Service Bulletin No. 3074

MODEL E / J Series Coaches	TYPE Product Improvement	SECTION/GROUP 7 – Electrical	DATE Nov. 13, 2012
SUBJECT ENGINE HARNESS CLAMP			
CONDITIONS Parts may be purchased from MCI Service Parts, Louisville, Kentucky.

Figure 1. Curbside, rear, side service compartment.

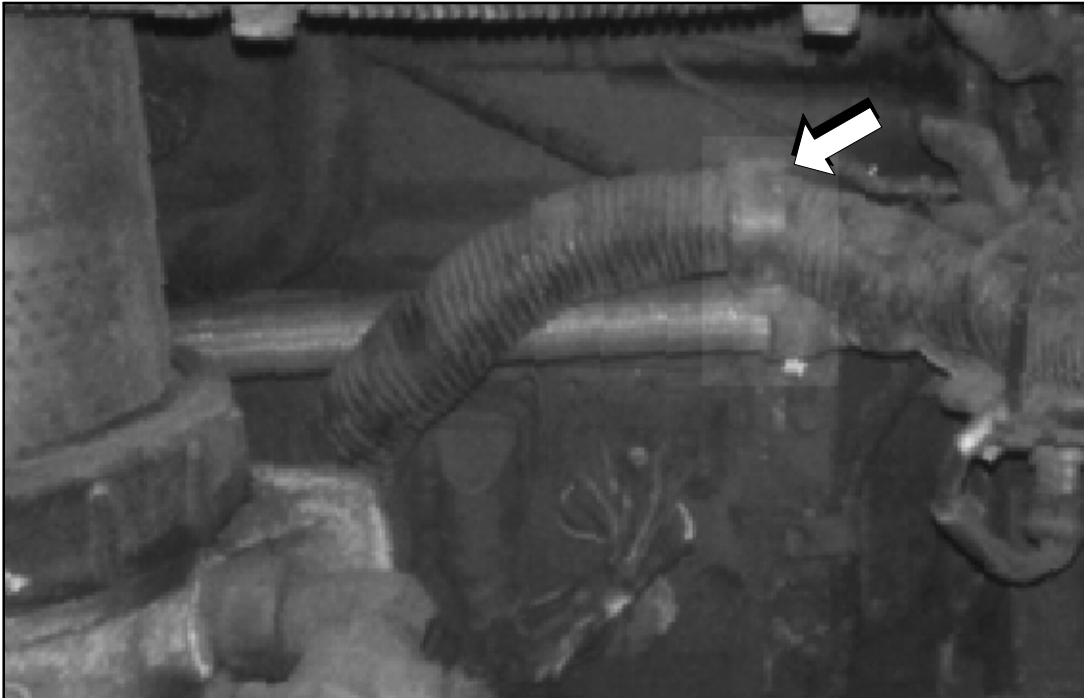
3. Open the curbside, rear, side service compartment door.
4. Locate the engine harness shown in Figure 1.
5. Locate and remove the existing p-clamp and mounting hardware in the location shown in Figure 1. Discard the existing p-clamp and mounting hardware.

Figure 2.

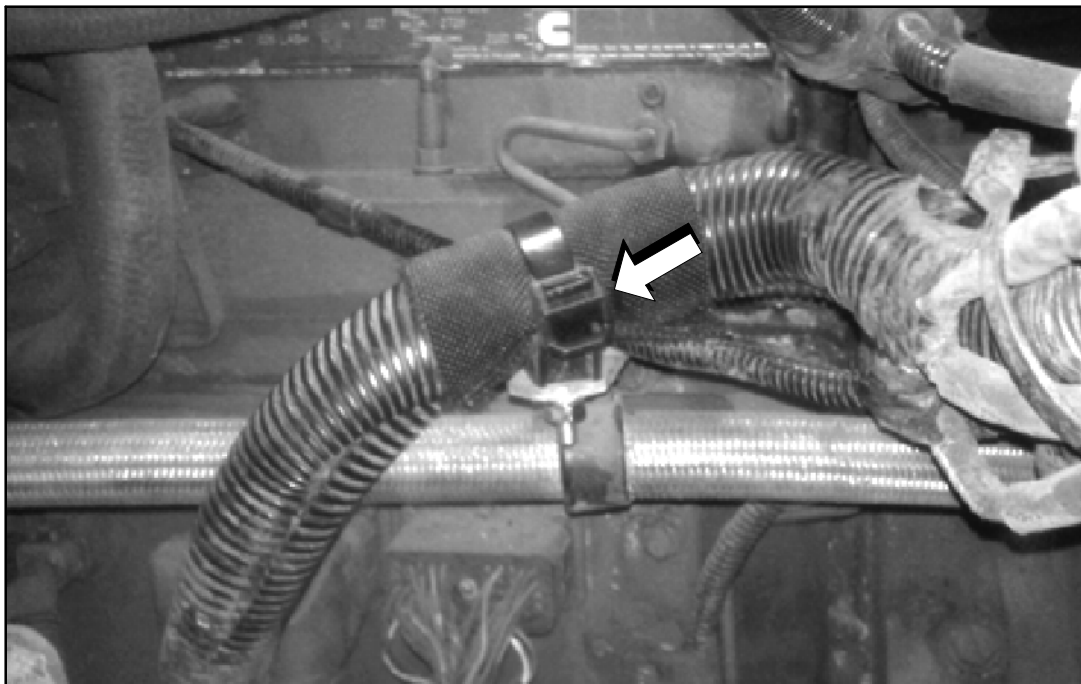
- 6. Mount the tie base, p/n 07-08-4552, using hardware p/n's 19-1-825, 19-3-228, 19-02-6063 and 19-02-6035 (refer to Figure 2).
- 7. Secure the harness using p/n's 07-08-4535 and 07-08-4527 (refer to Figure 2).

Figure 3.

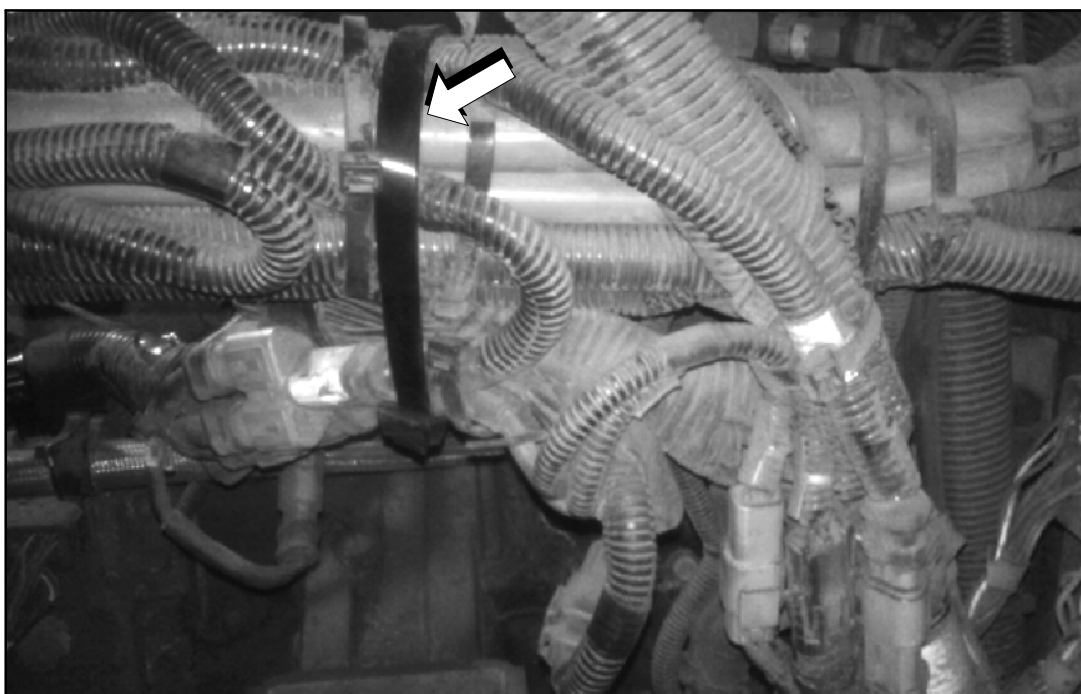
- 8. Secure the harness throughout its routing using p/n's 07-08-4535 and 07-08-4527 (refer to Figure 2).
